No. GHB 7 6 0 2  
 May 22, 2007  
 Cosel Co., Ltd.  
 Kuniaki Nagahara  
 General Manager  
 Unit Standard Dept.

## Appearance change Announcement

P B A 1 0 0 F : All models including semi-standard and modified product.

Picture 2.1 Comparison of appearance before and after change

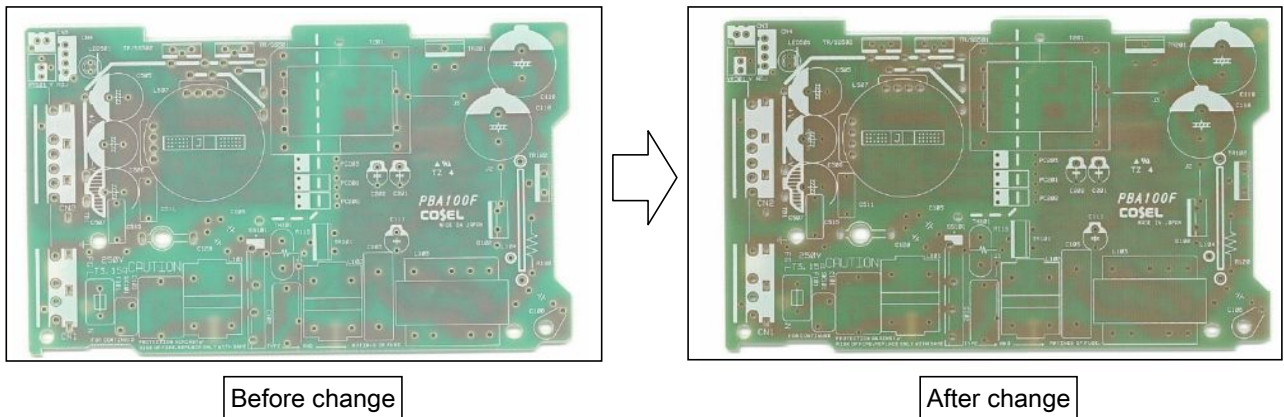
We change materials maker of PWB so that we can obtain components more easily.

Therefore the color of PWB changes as shown in picture 2.1.

However the characteristic of PWB does not change. Please refer to table 2.1.

This change will not affect specifications and approved safety standard of the power supplies.
